Release Notification and Corrective Action

Name of Company: El Paso Natural Gas Company, LLC (a Kinder Morgan owned company) 7046	Contact Sheila Castellano
Address: approximately 1.5 miles south of HW404 and 1.1 miles west of CR213(War Road)	Telephone No. (719) 520-3719
Facility Name: El Paso Natural Gas Company Line No. 1100	Facility Type 26-inch Natural Gas Pipeline
Surface Owner: Bureau of Land Management	Mineral Owner: BLM
API No.

2RP-4252

EPNG L1100 Spike Test Project_Manifold 5-6. Location of hydrostatic test water release.

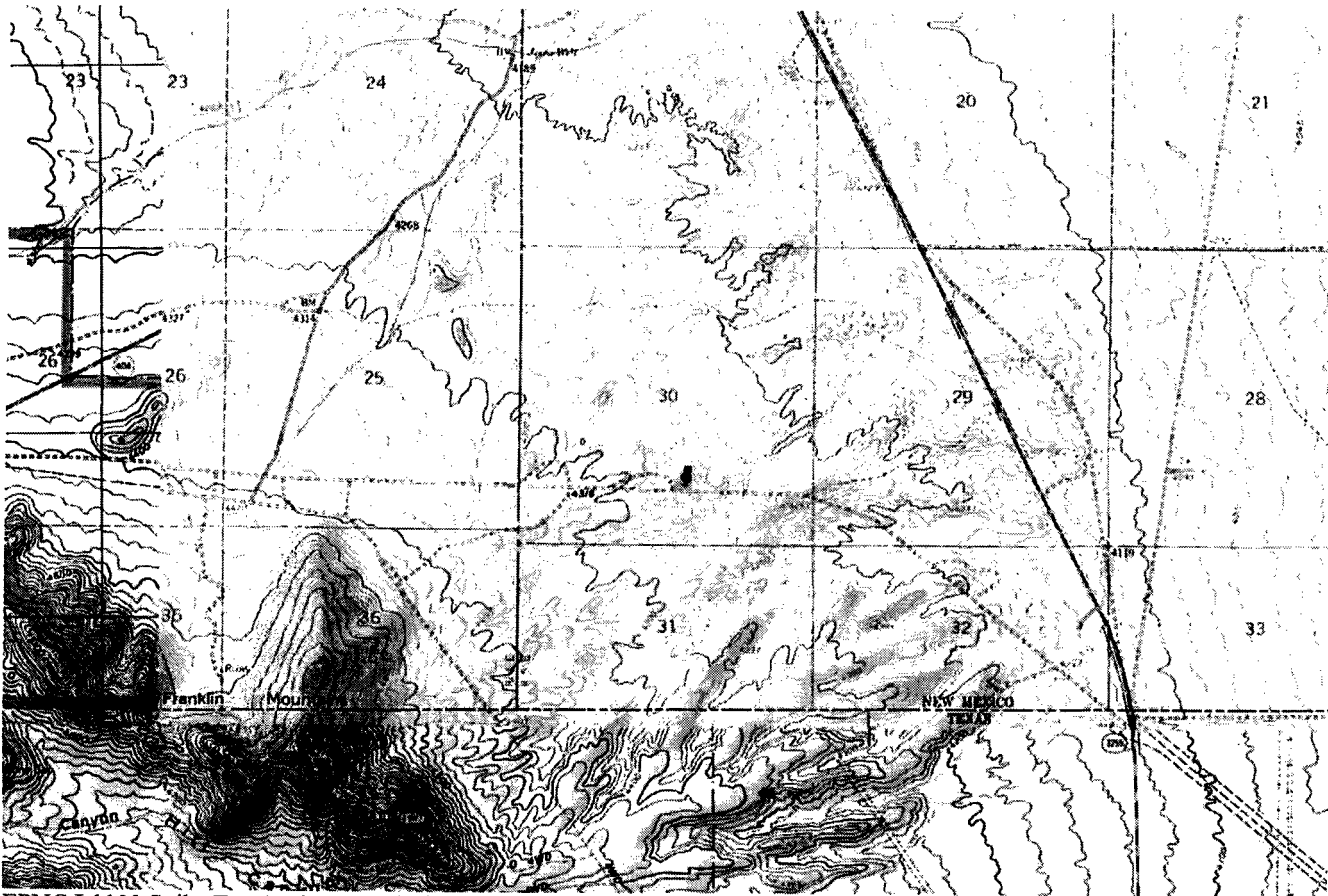
As mentioned in my verbal notification, this is a second release that occurred at the same location (Manifold 5-6) as the previous release which occurred on May 8, 2017. This release occurred as hydrostatic test water was being moved into a section for testing. No water left the right of way. All water was collected from the bell hole beneath the test manifold. The event occurred on land administered by the Bureau of Land Management.
